ZONING AMENDMENT,
PLANNED UNIT DEVELOPMENT,
PLANNING APPROVAL &
SUBDIVISION STAFF REPORT

Date: March 15, 2007

Pull-A-Part

Pull-A-Part Subdivision

SITE PLAN

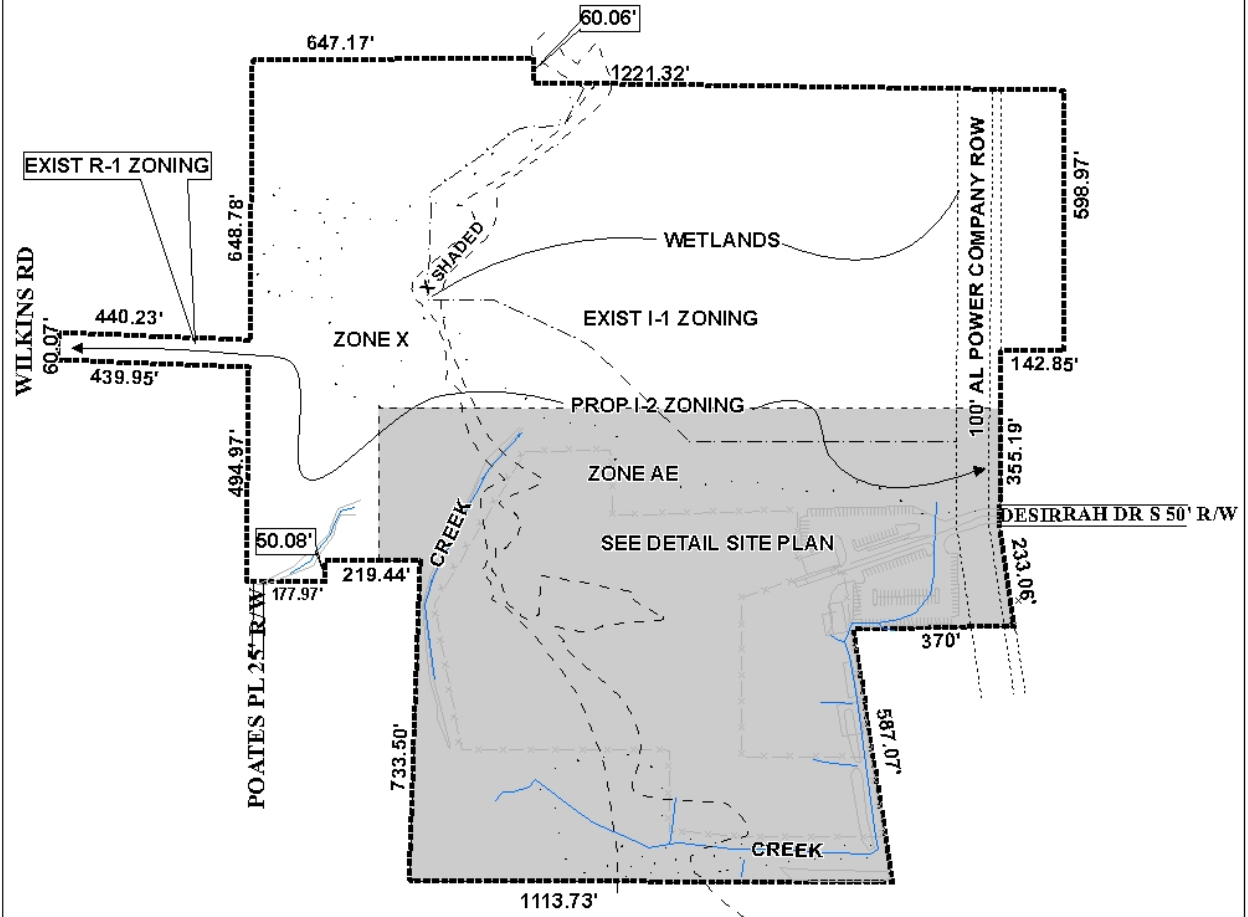
A drainage easement is required for swales accepting public water or the owner can relocate swales with City of Mobile's approval. Check direction of flow arrows shown on swales. The storm water ordinance does not allow water to be concentrated onto an adjacent property without a hold harmless agreement. All storm water must tie to the City of Mobile storm drainage system. Show limits of AE flood zone. Detention cannot be performed in the AE flood zone. Show minimum finished floor elevation for any buildings or structures and/or slabs, on which, mechanical and electrical equipment will be installed. The applicant is responsible for verifying if the site contains wetlands. The site can be checked against the National Wetlands Inventory on the COM web site Environmental Viewer. If the site is included on the NWI, it is the applicant's responsibility to confirm or deny the existence of regulatory wetlands. If wetlands are present, no fill allowed without a Corps of Engineers permit. Must comply with all storm water and flood control ordinances. Any work performed in the right of way will require a right of way permit.

The site is traversed by several drainage features and is located in the Three Mile Creek drainage basin. The provided site plan and subdivision plat, as well as National Wetlands Inventory and FEMA floodplain maps indicate that the site may be environmentally sensitive due to the potential presence of wetlands and floodplains. The approval of all applicable federal, state and local agencies will be required prior to the issuance of any permits or land disturbance activities.

While all adjacent streets are minor in nature, access management is a concern due to the proposed zoning of the site and its proximity to predominantly residential streets. It is recommended that access of the industrially-zoned site to Wilkins Road, Poates Place and Isabella Street be denied, leaving Desirrah Drive South as the only point of access to the auto salvage facility. The number, size, design and location of any curb-cut(s) must be approved by Traffic Engineering and conform to AASHTO standards. The plat and site plan should also be revised to depict the required minimum building setback line from all street frontages, where the building setback is not superseded by the 50-foot vegetative buffer.

- 4) full compliance with Engineering comments (A drainage easement is required for swales accepting public water or the owner can relocate swales with City of Mobile's approval. Check direction of flow arrows shown on swales. The storm water ordinance does not allow water to be concentrated onto an adjacent property without a hold harmless agreement. All storm water must tie to the City of Mobile storm drainage system. Show limits of AE flood zone. Detention cannot be performed in the AE flood zone. Show minimum finished floor elevation for any buildings or structures and/or slabs, on which, mechanical and electrical equipment will be installed. The applicant is responsible for verifying if the site contains wetlands. The site can be checked against the National Wetlands Inventory on the COM web site Environmental Viewer. If the site is included on the NWI, it is the applicant's responsibility to confirm or deny the existence of regulatory wetlands. If wetlands are present, no fill allowed without a Corps of Engineers permit. Must comply with all storm water and flood control ordinances. Any work performed in the right of way will require a right of way permit.);*

- 5) placement of a note on the PUD and Planning Approval site plans stating that approval of all applicable federal, state and local agencies is required prior to the issuance of any permits or land disturbance activities;*

- 6) revision of the PUD and Planning Approval site plans to accommodate a cul-de-sac or hammerhead turn-around for Desirrah Drive South, if determined necessary by Mobile Fire Rescue;*

- 7) placement of a note on the PUD and Planning Approval site plans stating that access to Wilkins Road, Poates Place and Isabella Street is denied;*

- 8) *placement of a note on the PUD and Planning Approval site plans stating that lighting of the site and the parking area must be in compliance with the requirements of Sections 64-4.A.2. and 64-6.A.3.c. of the Zoning Ordinance;*
- 9) *placement of a note on the PUD and Planning Approval site plans stating that compliance with the tree and landscaping requirements of the Zoning Ordinance to be coordinated with Urban Forestry;*
- 10) *depiction of the minimum building setback line from all street frontages, where it is not superseded by the 30-foot vegetative buffer;*
- 11) *provision of revised PUD and Planning Approval site plans to the Planning Section of Urban Development prior to the signing of the Subdivision plat; and*
- 12) *full compliance with all other municipal codes and ordinances.*

DETAIL SITE PLAN

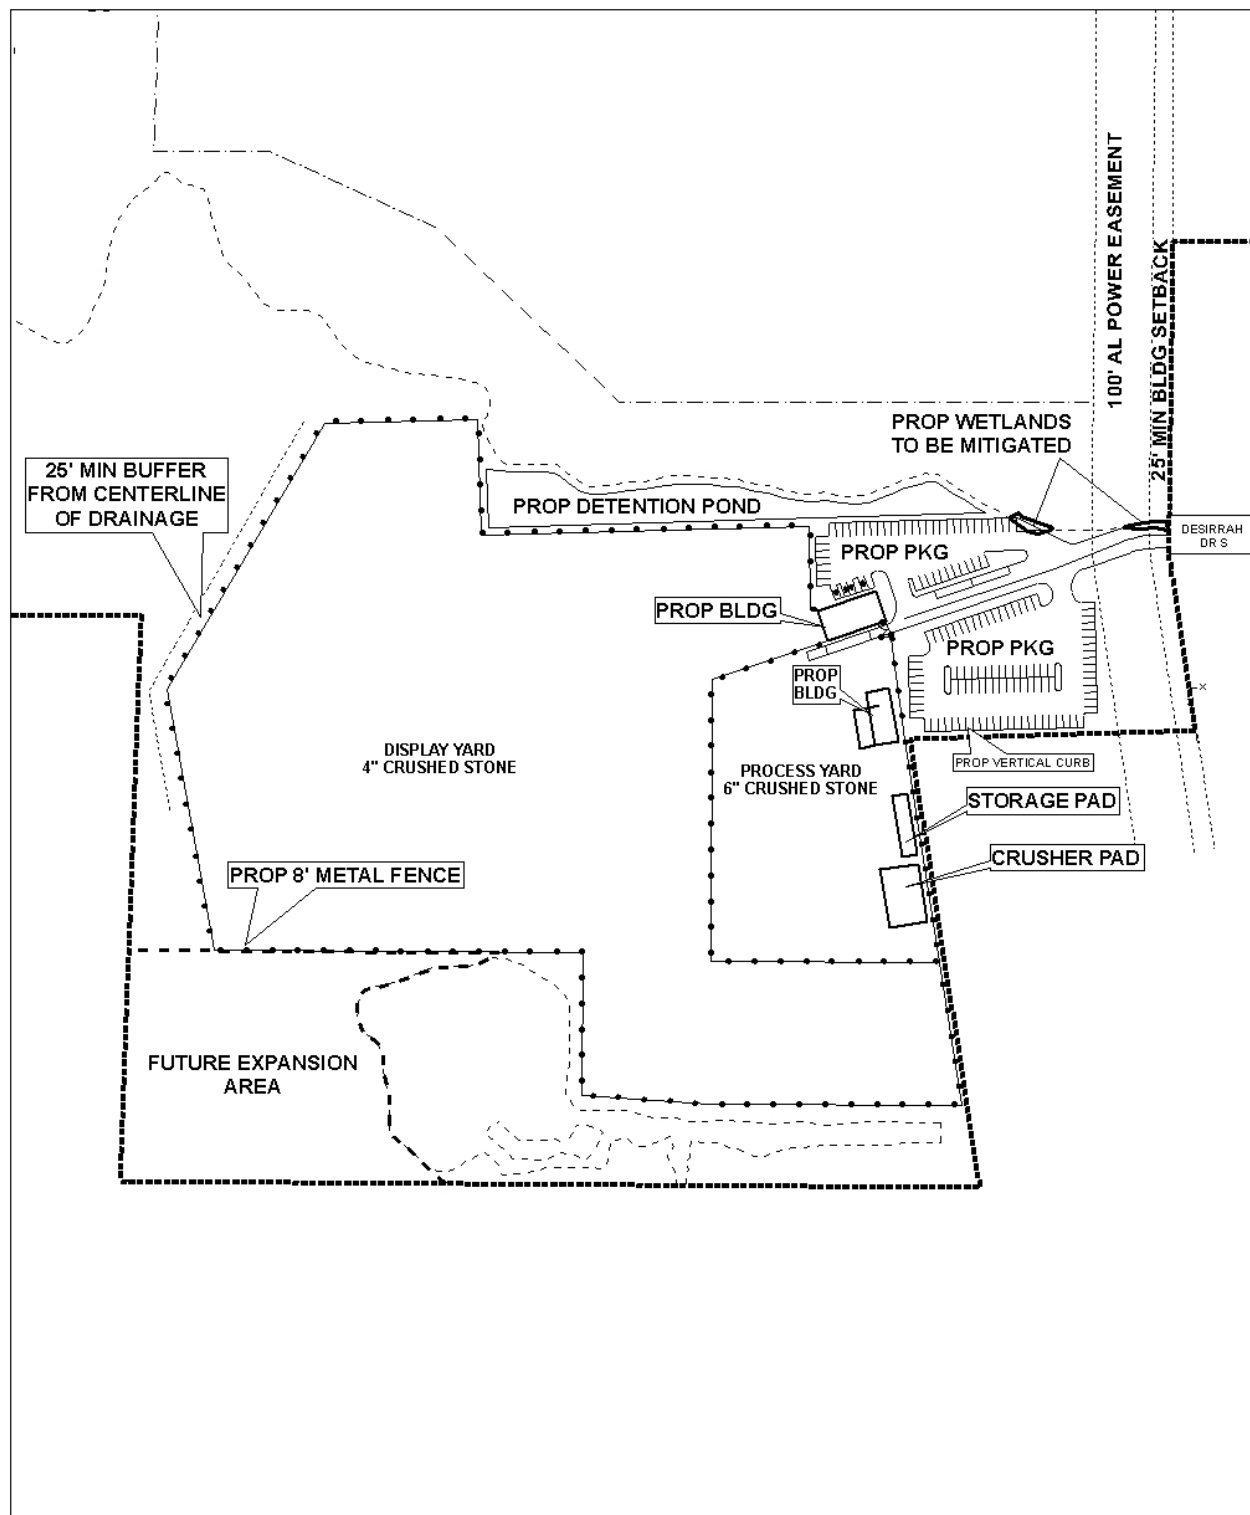
Regarding the specific use of the site for a self-serve auto salvage yard, the applicant is proposing that the more noise intensive uses (primarily the auto crusher) be located on the Eastern portion of the site, about as far away as possible from existing single-family residences located on the West side of the site. The bulk of the site that is developed will contain the vehicle display yard, which will be located between the more intensive aspects of the auto processing process and the single-family residences. A future expansion area is proposed for the Southwest corner of the site, and the remainder of the site, North of the proposed vehicle display yard and office building, will remain undeveloped. A 145-space employee and customer parking area is also proposed.

The vehicle display yard and the auto processing area will each be surrounded by an 8-foot high opaque fence, which will meet the fencing requirement of the Zoning Ordinance for such uses. In addition to the fence requirement, the proposed use must comply with Chapter 53, Article VII of the Mobile City Code, as recently amended (August, 2006), regarding automobile dismantling, crushing and shredding operations.

Lighting of the site and the parking area should be in compliance with the requirements of Sections 64-4.A.2. and 64-6.A.3.c. of the Zoning Ordinance; specifically lighting must not shine directly into adjacent residential properties or into traffic, and parking areas must be illuminated during their operation at night, if applicable.

- 4) *full compliance with Engineering comments (A drainage easement is required for swales accepting public water or the owner can relocate swales with City of Mobile's approval. Check direction of flow arrows shown on swales. The storm water ordinance does not allow water to be concentrated onto an adjacent property without a hold harmless agreement. All storm water must tie to the City of Mobile storm drainage system. Show limits of AE flood zone. Detention cannot be performed in the AE flood zone. Show minimum finished floor elevation for any buildings or structures and/or slabs, on which, mechanical and electrical equipment will be installed. The applicant is responsible for verifying if the site contains wetlands. The site can be checked against the National Wetlands Inventory on the COM web site Environmental Viewer. If the site is included on the NWI, it is the applicant's responsibility to confirm or deny the existence of regulatory wetlands. If wetlands are present, no fill allowed without a Corps of Engineers permit. Must comply with all storm water and flood control ordinances. Any work performed in the right of way will require a right of way permit.);*

- 5) *placement of a note on the PUD and Planning Approval site plans stating that approval of all applicable federal, state and local agencies is required prior to the issuance of any permits or land disturbance activities;*

- 6) *revision of the PUD and Planning Approval site plans to accommodate a cul-de-sac or hammerhead turn-around for Desirrah Drive South, if determined necessary by Mobile Fire Rescue;*

- 7) *placement of a note on the PUD and Planning Approval site plans stating that access to Wilkins Road, Poates Place and Isabella Street is denied;*

- 8) *placement of a note on the PUD and Planning Approval site plans stating that lighting of the site and the parking area must be in compliance with the requirements of Sections 64-4.A.2. and 64-6.A.3.c. of the Zoning Ordinance;*

- 9) *placement of a note on the PUD and Planning Approval site plans stating that compliance with the tree and landscaping requirements of the Zoning Ordinance to be coordinated with Urban Forestry;*
- 10) *depiction of the minimum building setback line from all street frontages, where it is not superceded by the 30-foot vegetative buffer;*
- 11) *provision of revised PUD and Planning Approval site plans to the Planning Section of Urban Development prior to the signing of the Subdivision plat; and*
- 12) *full compliance with all other municipal codes and ordinances.*
